## 6.1.2 Use and Development of the Land for a Dwelling and Removal of Vegetation at 369 Paternoster Road, Cockatoo

**File Reference:** 2672303400TP/1  
**Responsible GM:** Peter Benazic  
**Author:** Mary Rush

That Council issue a Refusal to Grant Planning Permit T180651 be issued for Use and development of the land for a dwelling and removal of vegetation at 369 Paternoster Road, Cockatoo VIC 3781 on the following grounds:

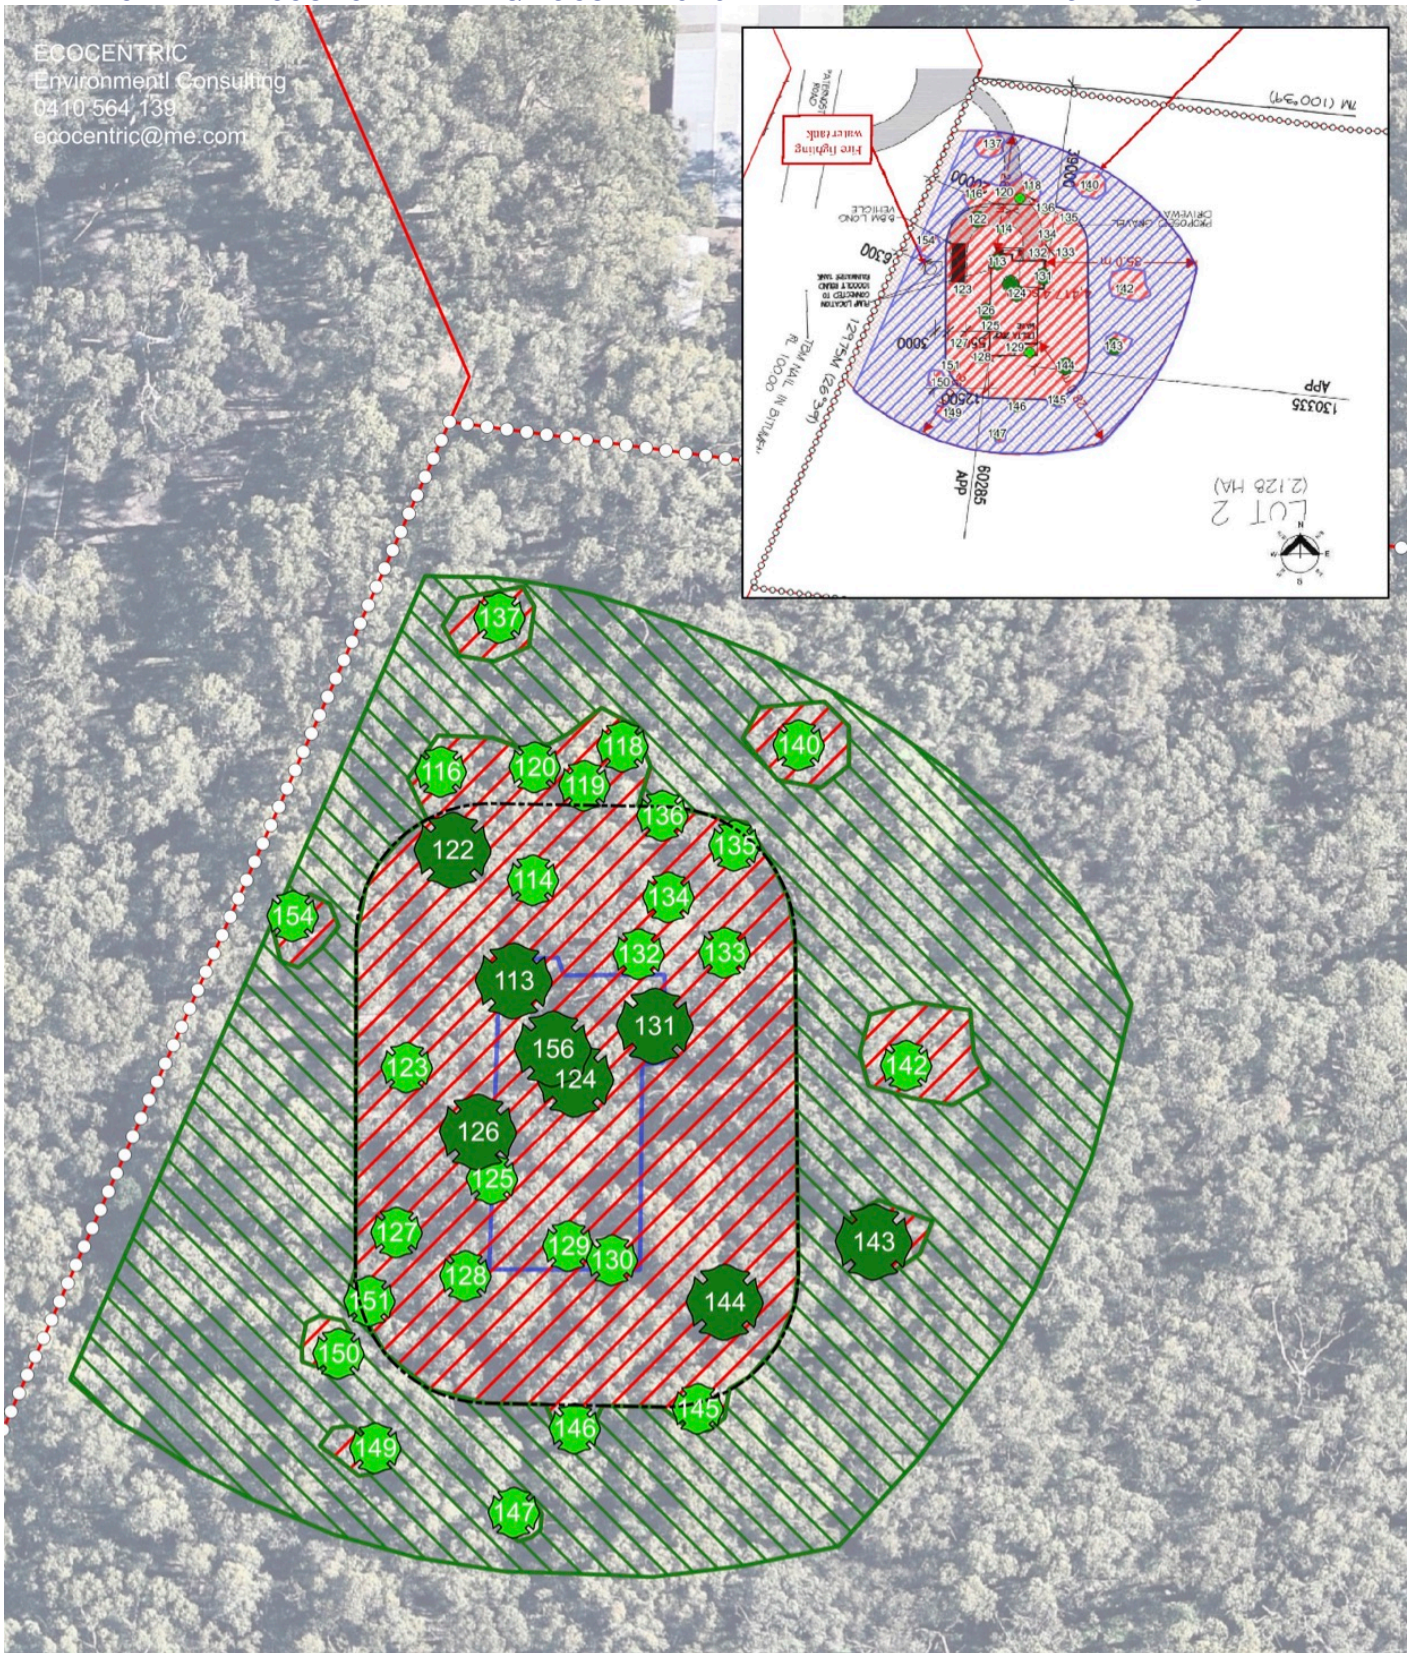
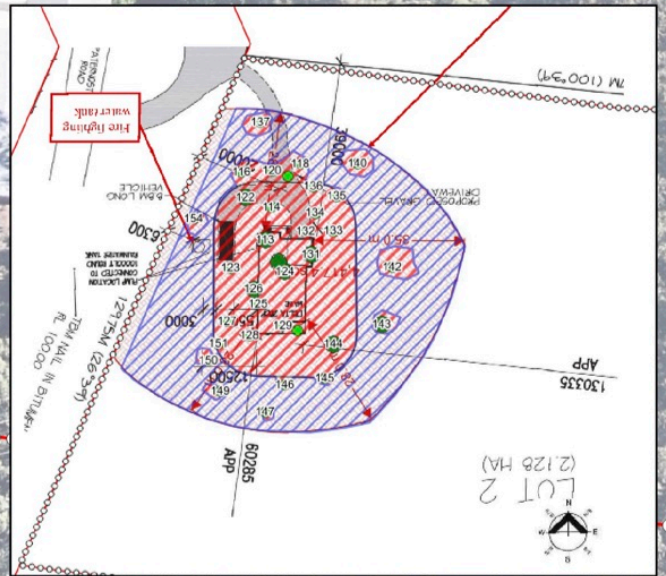
This report and plan identifies the vegetation that is required to be removed within the dwelling footprint and the defensible space of the dwelling. The proposed vegetation removal plan shown below with trees proposed for removal shown in red:

The applicant was requested to provide some additional information which is critical to assessing the full impact on the vegetation. The current plan only includes trees up to five (5) metres in height, whereas there are many trees over three (3) metres in height which are required to be managed as part of the defensible space, and these have not been shown. There are other details required by the Guidelines that Council have requested that the applicant provide, so that the full impacts of the proposal will have on vegetation loss and biodiversity can be assessed. For example the plan must show hollow bearing trees that provide nesting hollows so that Council can ensure that these trees are retained.

In order to meet the CFA's vegetation management requirements, the (five) 5 metre canopy separation must be provided. A review of the proposed vegetation removal plan on site by Council's Environment Officer, has determined that the 5 metre distance has not been provided in several instances. The plan must demonstrate that the 5-metre separation between tree canopies will be met. Where pruning of the canopy is recommended to meet this requirement, the applicant needs to demonstrate that the canopy pruning required will not impact the ongoing viability of the tree. Failure to adequately provide the canopy separation will increase the intensity of fire and the occupant of any dwelling will be at risk as the Bushfire Attack Level (BAL) that the dwelling is constructed to, may not withstand the intensity of the fire.

**Bushfire Management Overlay Assessment: Paternoster Rd 369, Cockatoo**

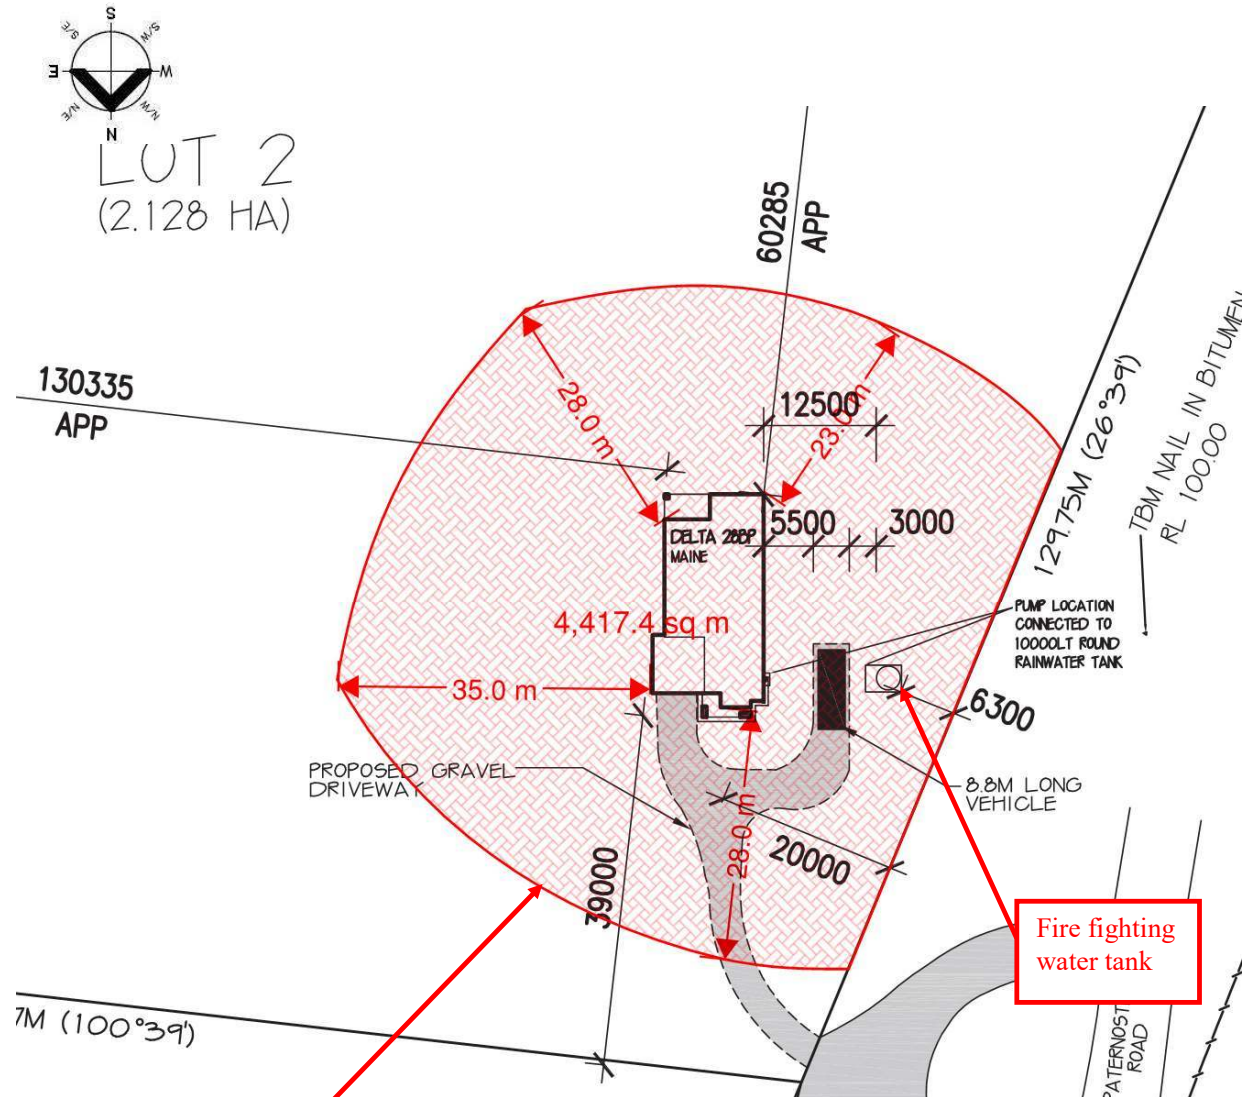
The current site plan, provided in the *Bushfire Management Overlay Compliance Assessment* by Greenwood Consulting (20/12/2019) must be drawn to scale and updated to include the following:

4. Delete the proposed tree removals from the table that are outside the defendable space area (trees 18, 21, 22, 23, 27, 31, 32, 34, 35, 37, 43, 44, 46, 48, 355, and 454)

The proposed tree removal plan to meet the 5-metre canopy separation requirements must be reviewed

1. The plan must demonstrate a 5-metre separation between tree canopies will be met, and that where pruning is recommended to meet this requirement it will not impact the ongoing viability of the tree.

4. Trees adjacent to the canopy of retained trees cannot be considered a clump.
5. Clumps of understory vegetation that will be retained must also be shown on the scaled site plan, and described in the ecology report. The BMO requires that understory vegetation in the defensible space area meets the following requirements:
